**EXPLANATION OF SIGNIFICANT DIFFERENCES
REPORT (ESD) FOR THE SOUTH
GROUNDWATER CONTAMINATION PLUME
REMOVAL ACTION EE/CA**

12/17/91

Enclosure 1

FIGURE 1
New location of Recovery
Well Field

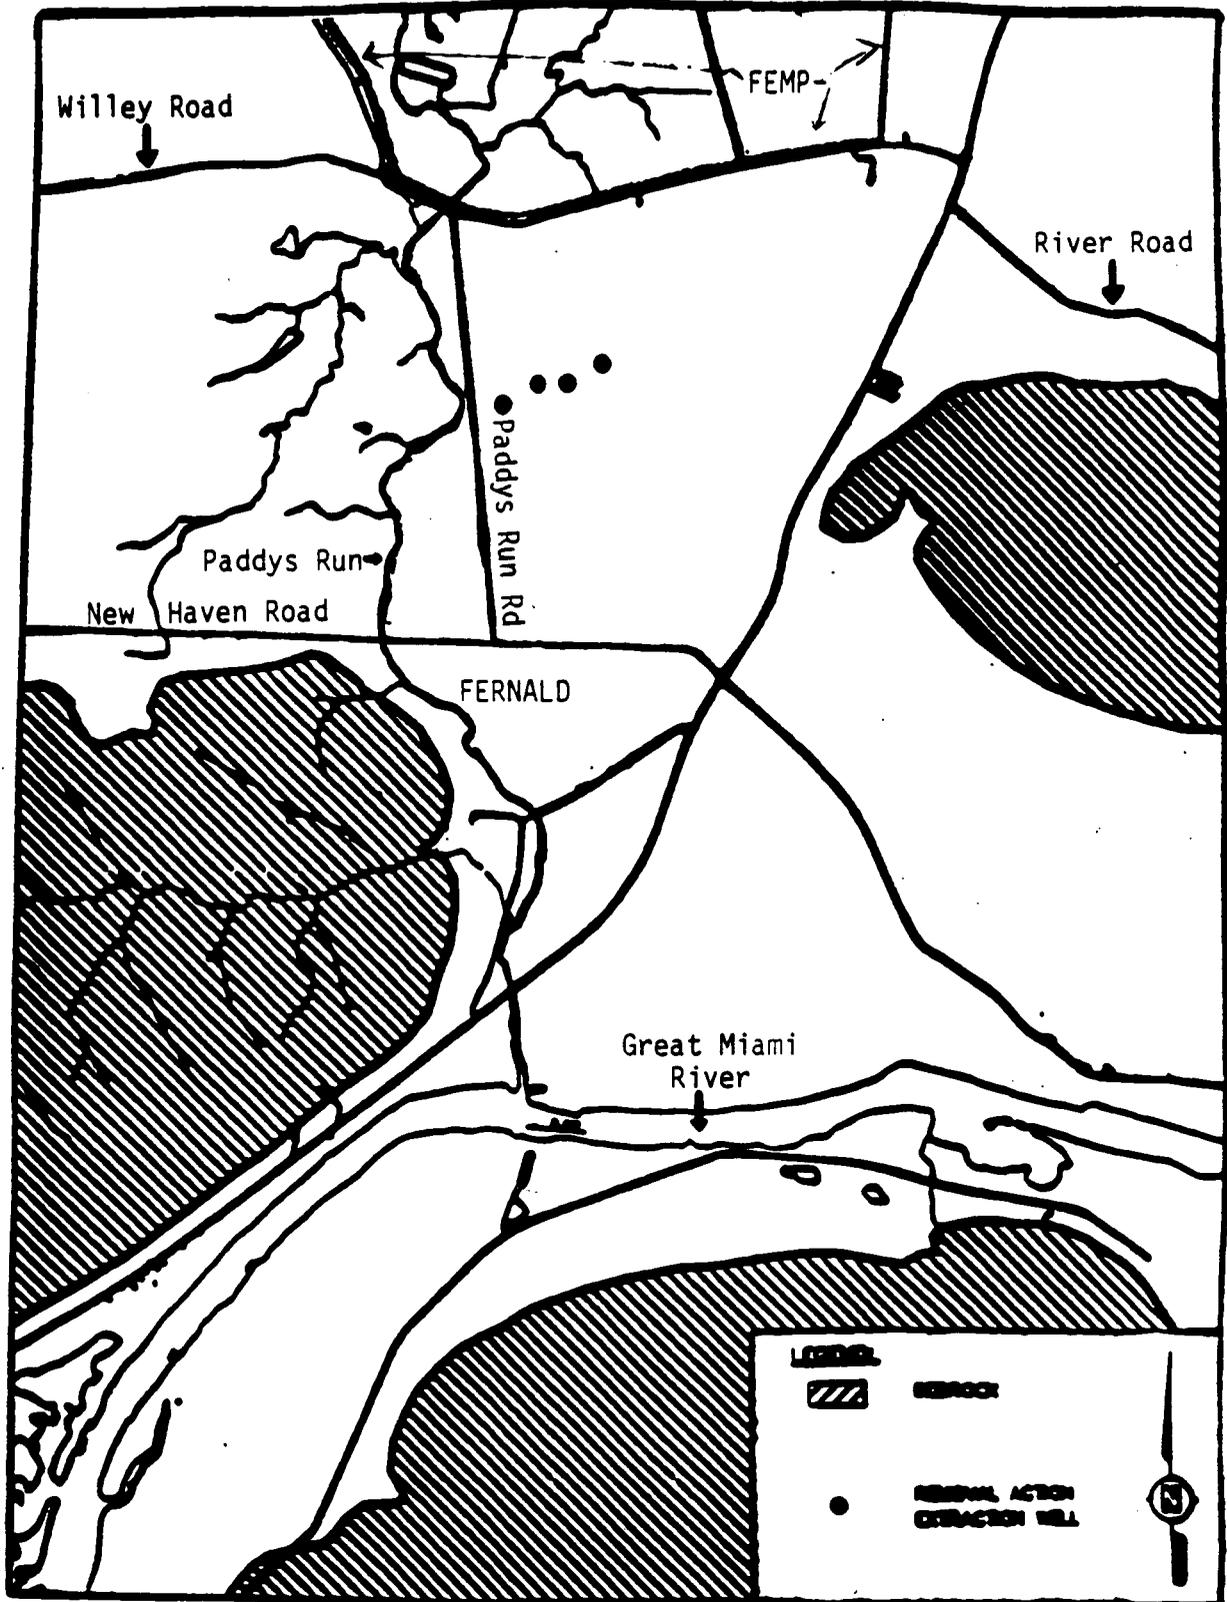
As a result of these conditions, it has been deemed necessary to relocate the Part 2 well field to an area north of the PRRS. Modeling efforts have been performed to determine a location where pumping of the recovery well field will not significantly affect the PRRS plume and will not draw PRRS contaminants into the recovery well field. Figure 1 depicts the new location of the South Plume Removal Action Part 2 well field.

Paragraph 4, 1st Sentence is modified to read: Three to five recovery wells are tentatively planned for installation north of the Albright & Wilson Americas (AWA) Plant. The recovery wells are shown conceptually in Figure 1 of this Addendum.

Figure 3 FEMP Outfall Pipeline Site Plan

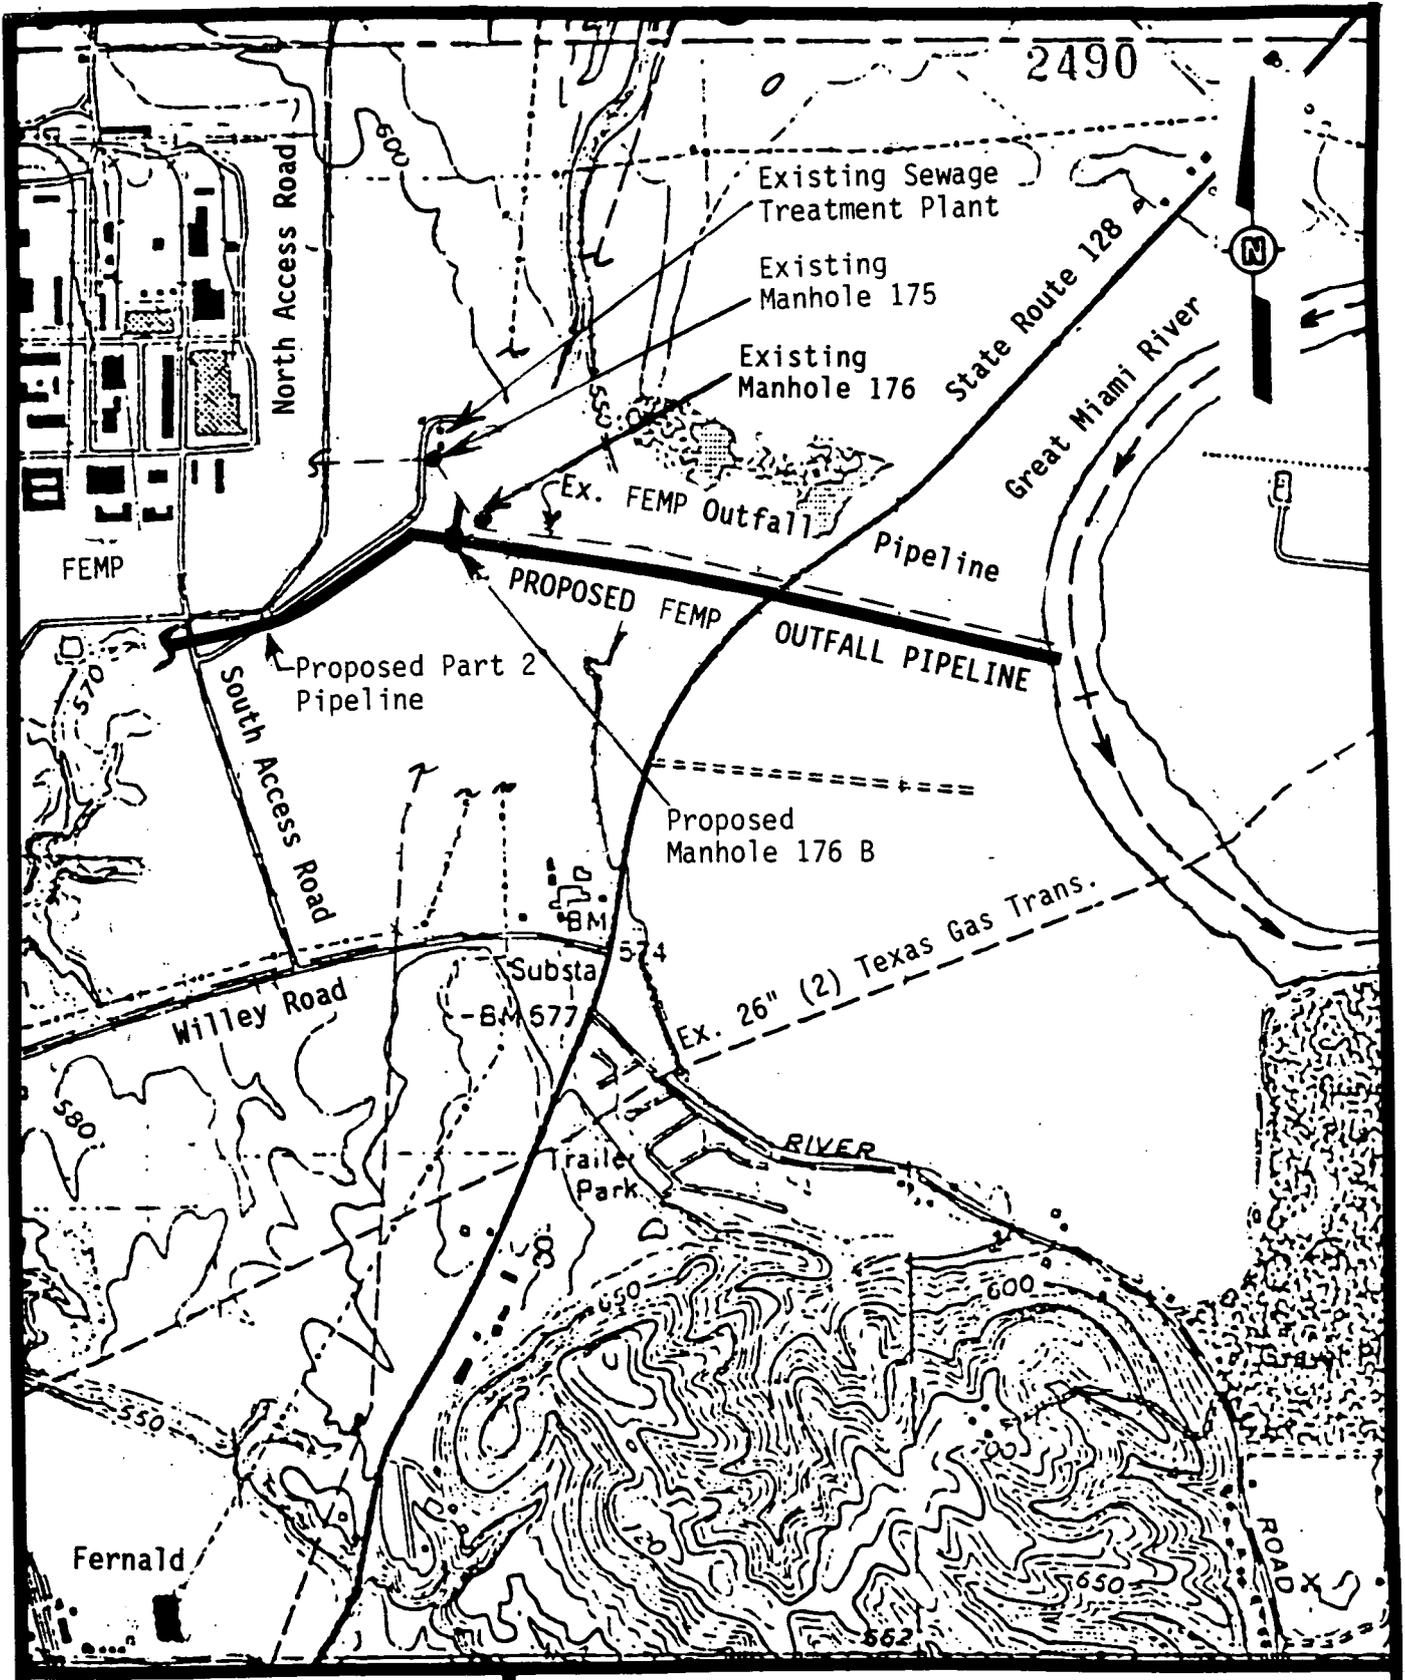
In addition, the existing FEMP effluent pipeline to the Great Miami River (GMR) has been evaluated as part of Operable Unit (OU) 3 for structural integrity and capacity to accept additional discharge. It has been determined that, due to the age and uncertainties associated with the existing effluent pipeline downstream of the proposed Part 2 pipeline tie-in, the portion of the existing effluent pipeline downstream of the Part 2 pipeline tie-in will be abandoned and a new portion of effluent pipeline will be installed as part of OU5 and incorporated into Part 2 of the South Groundwater Contamination Plume Removal Action (see Figure 3). The new effluent pipeline will begin at a location approximately fifty feet south of existing Manhole 176 and will parallel the existing effluent pipeline to the GMR. Future flow passing through the existing National Pollutant Discharge Elimination System (NPDES) monitoring point at Manhole 175 will be diverted from the existing effluent pipeline near Manhole 176 and flow to a new Manhole 176B located at the upstream end of the new effluent pipeline. The flow from the South Plume Part 2 recovery well field will be monitored as a new NPDES discharge and will also join the new effluent pipeline at Manhole 176B. Other than short term construction impacts, the installation of the new effluent pipeline will not adversely affect the GMR as the mass of uranium discharged will not be increased, but in fact will actually be decreased from 1862 pounds per year to 1700 pounds per year. The only effect of the effluent pipeline relocation will be to move the point of effluent discharge to the GMR slightly downstream from the existing point of effluent discharge. Therefore, cumulative impacts from the project will not adversely affect the environment.
